Marriott Hotel at Cesar Chavez

Date: May 17, 2017
To: Austin Design Commission
From: Planning & Urban Design Working Group
Subject: Working Group Density Bonus Program review of "The Marriott Hotel at Cesar Chavez" for substantial compliance with the Urban Design Guidelines.
Meeting Date: May 12, 2017; 12:00 pm
Applicant: Richard T. Suttle, Jr.- Armbrust & Brown, PLLC
Architect: HKS

DESIGN COMMISSION WORKING GROUP COMMENTS REGARDING PROJECT'S COMPLIANCE WITH URBAN DESIGN GUIDELINES

SCALE: N.T.S.

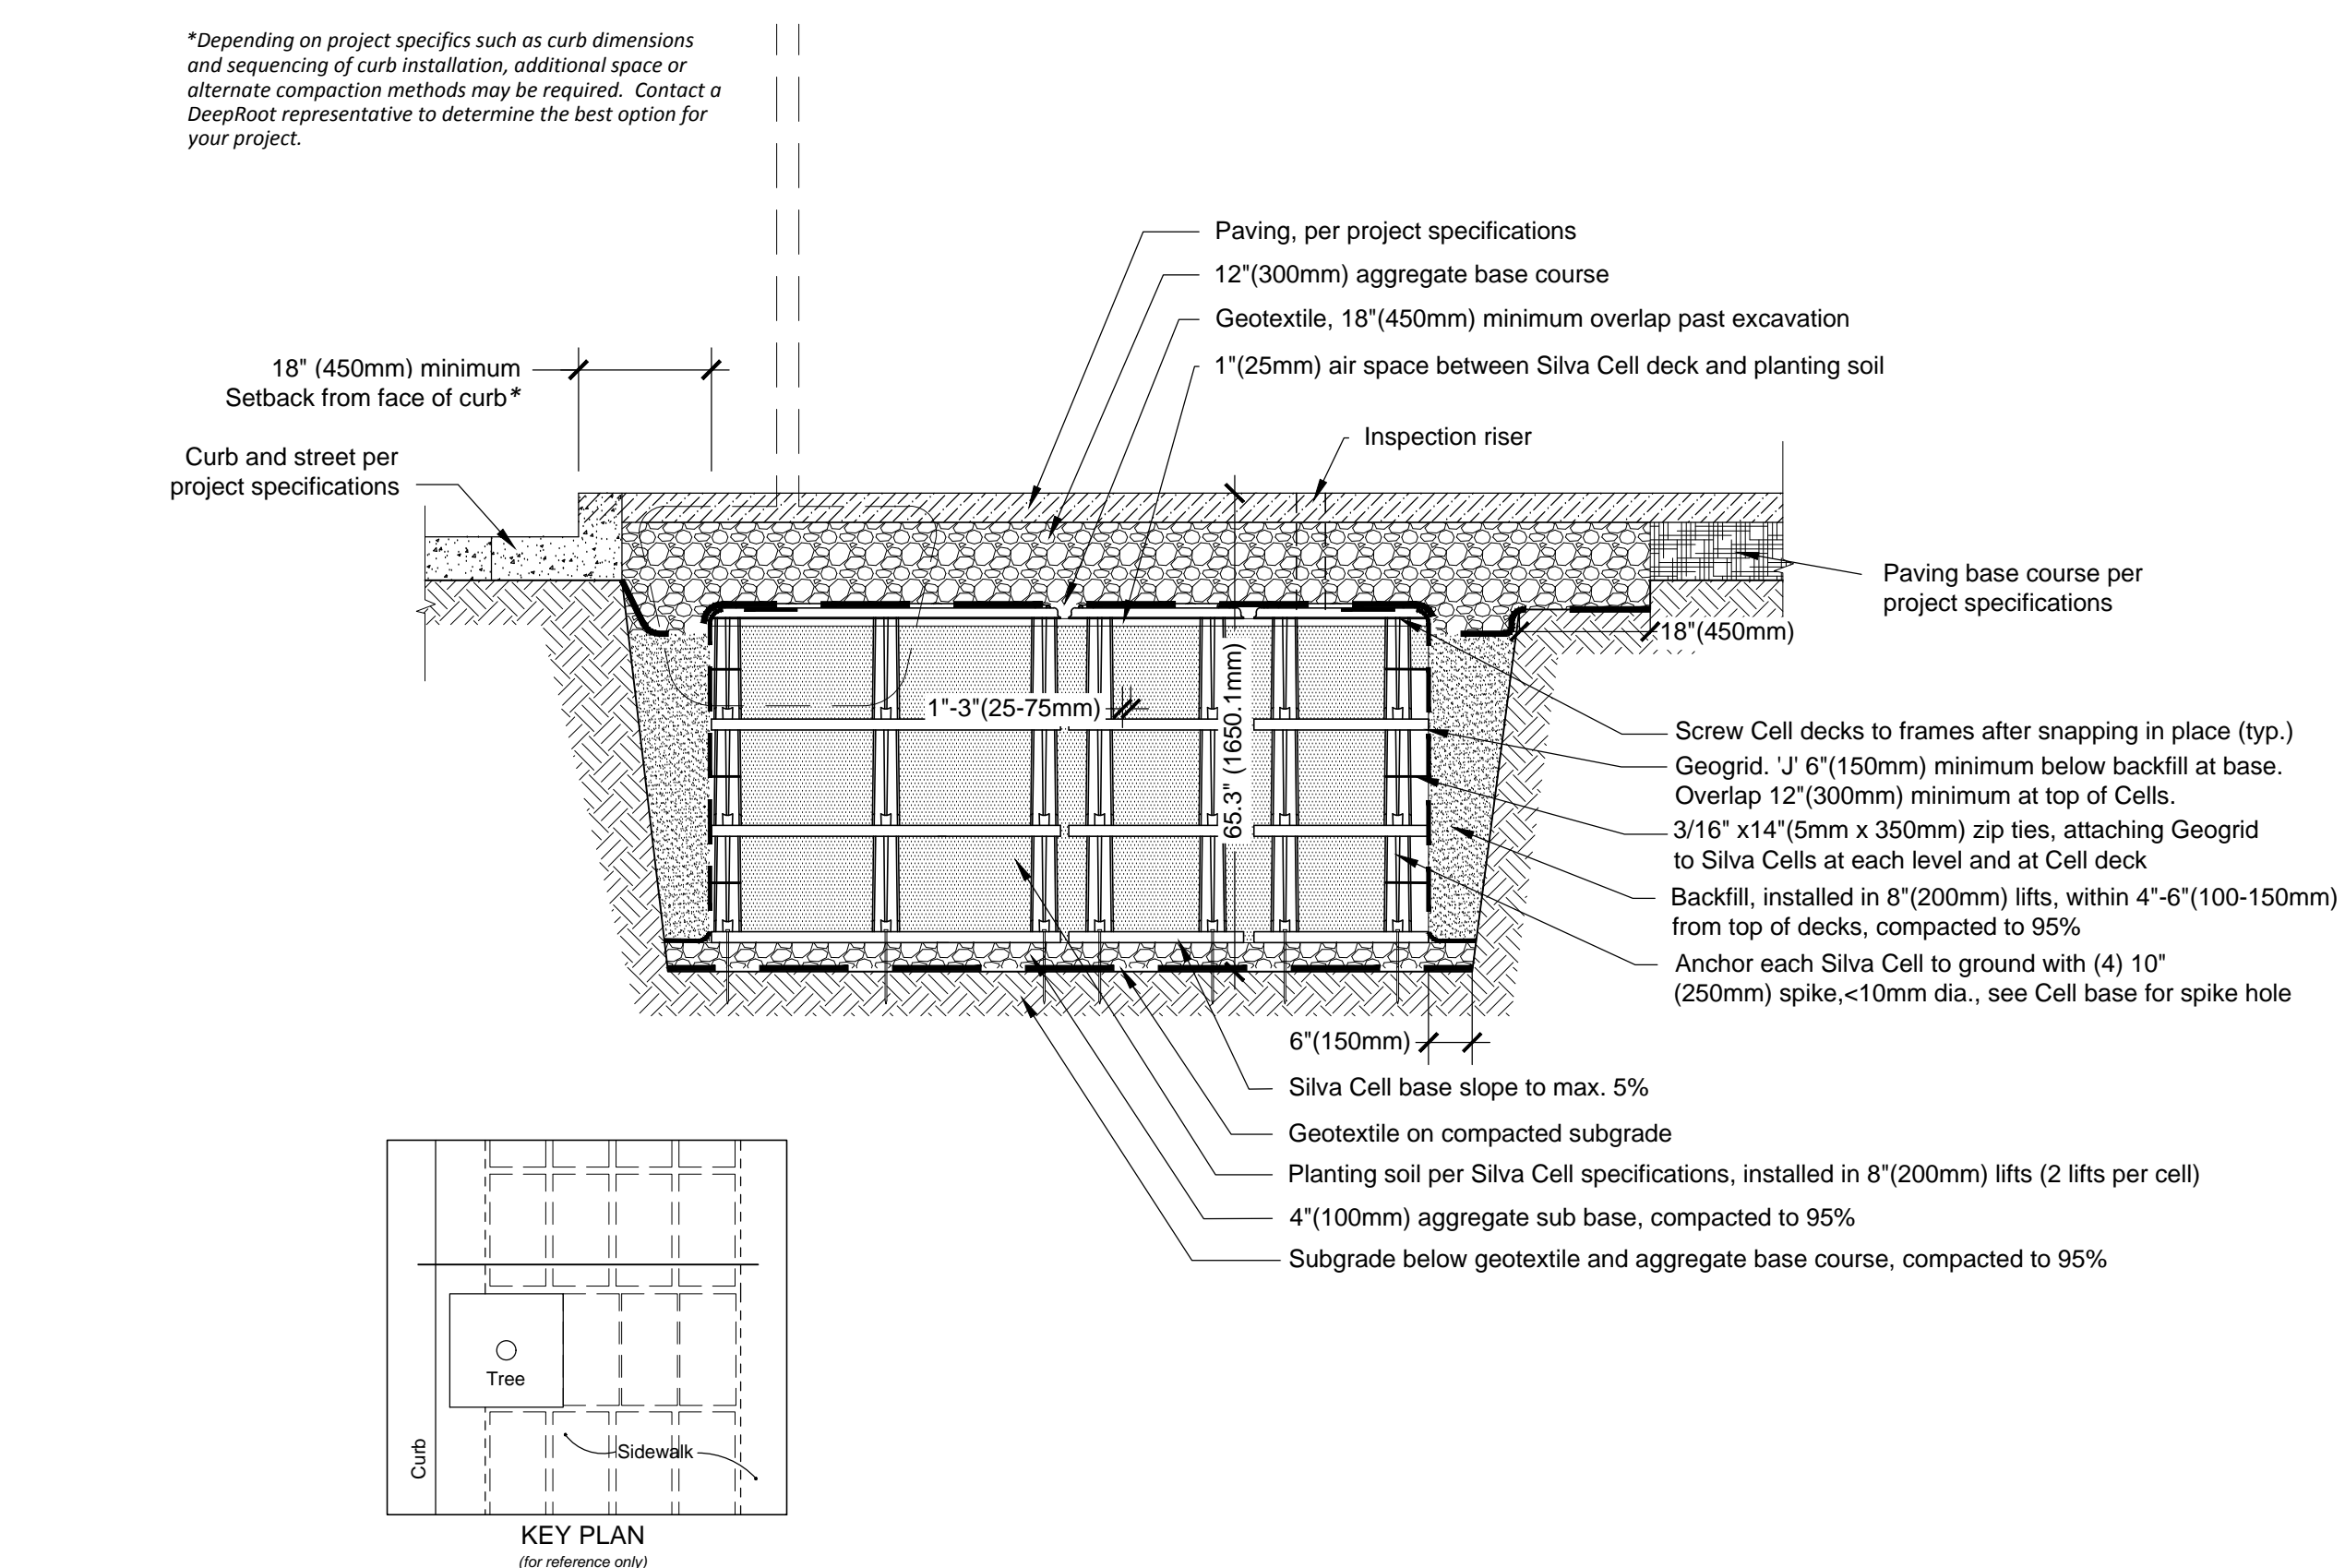
- The large tree in the middle of the property is a 40" Hackberry which is not a Heritage Tree species. We are mitigating the removal inches at the 300% mitigation rate.
- The trees along Trinity range from 13"-19". Given their location on the property line and the desire to construct sub-grade parking, the critical root zones would be impacted. There were also construction sequencing, traffic control challenges in this location and tower crane location considerations, which led to the decision to remove and mitigate the trees.
- In order to meet the Code required mitigation for these trees, we would be required to pay \$15,300 into the Urban Tree Fund. Through our coordination efforts with Keith Mars, Humberto Rey and various other reviewers, we arrived at the proposed plan (outlined below) as the most favorable option.

- Great streets compliance on Cesar Chavez, Trinity and San Jacinto
- 5", Bigtooth Maples on Trinity Street
- 5", Red Oaks on San Jacinto
- 5", Live Oaks on Cesar Chavez
- White Lodging has also committed to Silva Cells along each street, to aid in faster growth, larger canopies and more mature trees. The cost estimate values the upgrade to the suspended pavement system to be approximately \$74,043, in addition to the trees being planted. See attached cost estimate provided by DeepRoot Green Infrastructure, LLC and the corresponding design plan.

The mitigation plan will result in more trees than currently exist, a consistent great streets pedestrian environment on all adjacent public street frontages, and offer a better design and public realm experience. This mitigation plan is the result of many conversations, meetings and discussions with Keith Mars. The value of the mitigation is also nearly 5X that of meeting the Code minimum and paying into the tree fund.
